Form 3160-5
(June 2019)UNITED STATES
DEPARTMENT OF THE INTERIOR
BUREAU OF LAND MANAGEMENTFORM APPROVED OMB
No. 1004-0137 Expires:
December 31, 2024**SUNDRY NOTICES AND REPORTS ON WELLS**
Do not use this form for proposals to drill or to re-enter an
abandoned well. Use Form 3160-3 (APD) for such proposals.5. Lease Serial No. **NMLC 062486**

Operator: Acacia Operating Co., LLC
Plug By: Trigg Oil and Gas LTD
Well Name Drickey Queen Sand Unit #824
API # 30-005-00989
Location: Sec 4, T14S, R31E

**Drickey Queen Sand Unit 824
30-005-00989
Trigg Oil Co.
January 22, 2025
Conditions of Approval**

PROPOSED WELBORE

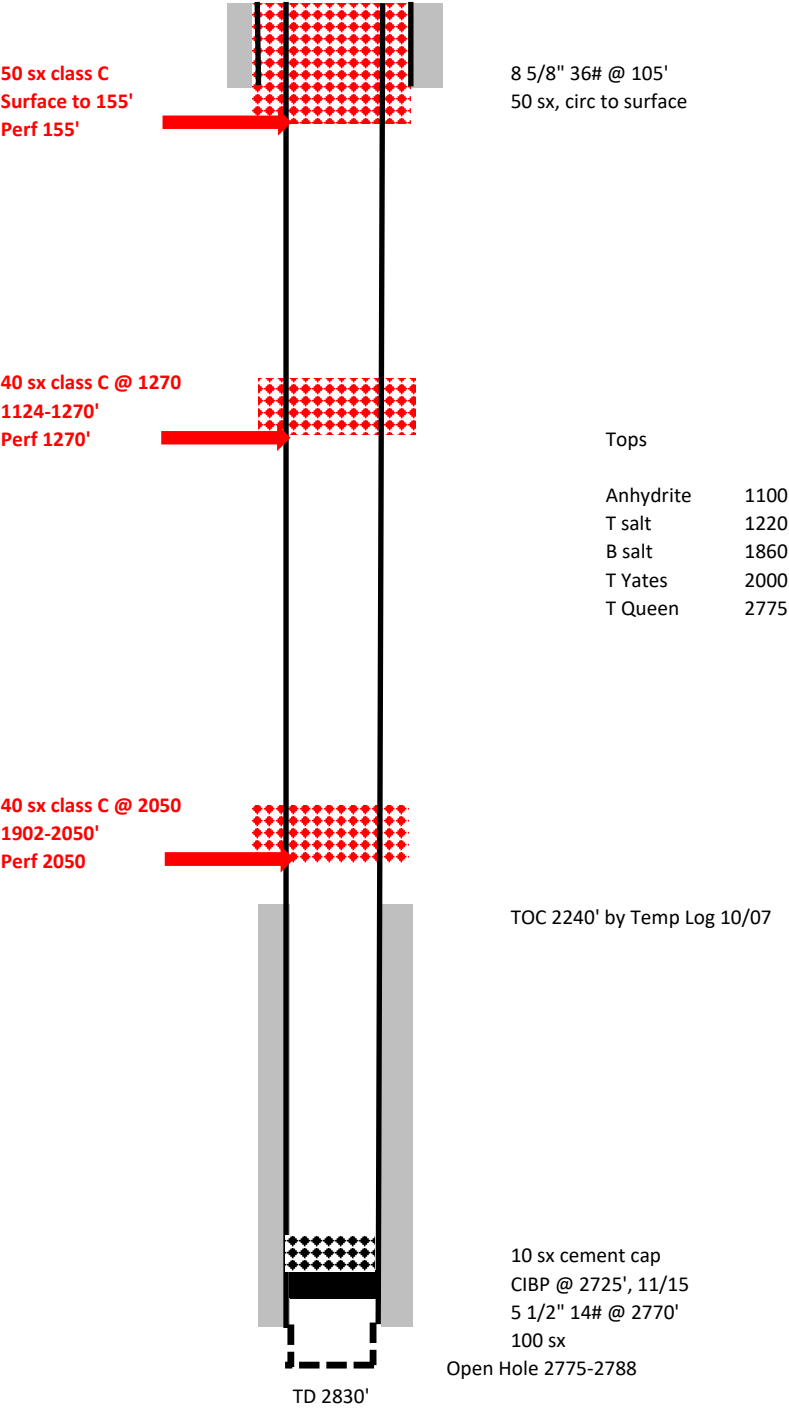
- 1. Operator shall TAG CIBP with 10 sx cement. Operator shall place an additional 15sx cement. WOC and TAG.**
- 2. Operator shall perf at 2,050' and squeeze cement class C cement to 1,779' to seal the Yates and bottom of the Salt. WOC and TAG.**
- 3. Operator shall perf at 1,270' and squeeze cement class C cement to 1,052' to seal the top of the Salt and the Rustler. WOC and TAG.**
- 4. Operator shall perf at 155' and squeeze cement class C cement to surface to seal the 8-5/8" casing shoe.**
- 5. Dry hole marker must be below ground.**
- 6. Surface reclamation will need to be completed once the well bore has been plugged. Please contact rflores@blm.gov for additional information.**
- 7. See Attached for general plugging stipulations.**
